Access Compliance Report

(Curb Ramps)

Intersection ID: 10745	Main Street: E_35TH_ST	Cross Street: HOLT_ST	Location: S
ADA ID: A0EC7B0DF595	Ramp Type: Perp	Initial Pass/Fail: Pass	Overall Compliance: No
Codes/Mitigation Info/Possible Solution		Field Measurements/Component Compliance	
Severity Score: 15

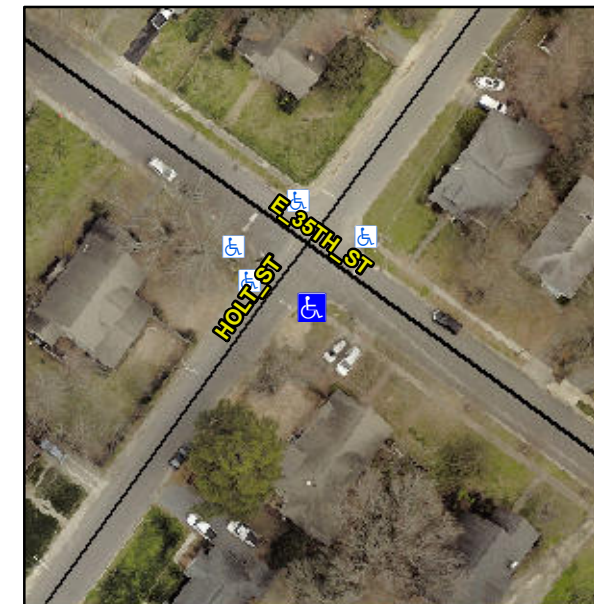
**Not Found, R304.2.1, R304.2.2-Perp,
R304.3.2-Para, R304.5.3, R304.5.4**

Compliance	Description	Data	Compliance	Description	Data
N/A	Ramp Length (in)	41.5	Yes	Ramp Slope (%)	7.6
Yes	Ramp Width (in)	48.0	Yes	Ramp XSlope (%)	0.3
N/A	Flare Type LT	Sloped	N/A	Flare Type RT	N/A
N/A	Flare Slope LT (%)	9.5	N/A	Flare Slope RT (%)	9.2
N/A	Flare Traversable LT?	No	N/A	Flare Traversable RT?	No
No	Landing Length (in)	N/A	Yes	DWS Provided?	Yes
No	Landing Width (in)	N/A	Yes	DWS Contrast?	Yes
No	Landing Slope (%)	N/A	Yes	DWS Length (in)	24.0
No	Landing X Slope (%)	N/A	Yes	DWS Full Width?	Yes
N/A	Landing Curb? (Y/N)	No	Yes	DWS Offset (in)	0.0
N/A	Shared Landing?	No			
Yes	Gutter Ponding?	No	No	Gutter Slope (%)	5.7
Yes	Gutter Lip Ht (in)	0.0	Yes	Gutter X Slope (%)	1.8
N/A	Painted X Walk1?	No	N/A	Painted X Walk2?	N/A
	X Walk 1 Direction	To NW		X Walk 2 Direction	N/A
N/A	X Walk 1 Width (in)	N/A	N/A	X Walk 2 Width (in)	N/A
	X Walk 1 Slope (%)	0.6		X Walk 2 Slope (%)	N/A
	X Walk 1 X Slope (%)	1.0		X Walk 2 X Slope (%)	N/A

**Remove & Replace Entire Ramp.
Remove & Replace Gutter.**
